Class II change

The modification of TPM-167, Data applies to: TC-400 (changed From TPM167, FCC ID: LJL041201T), The detail description of modification as belows:

Bottom View

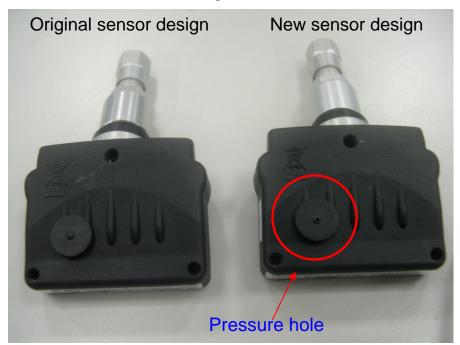
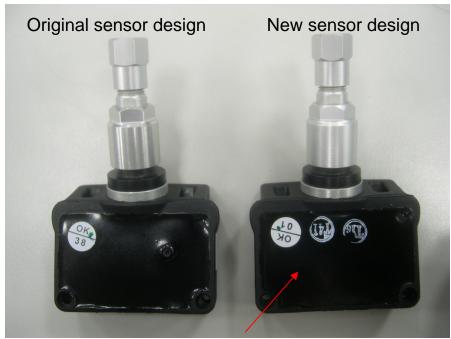
1. New edition sensor the different is the position of pressure hole.

Pressure hole
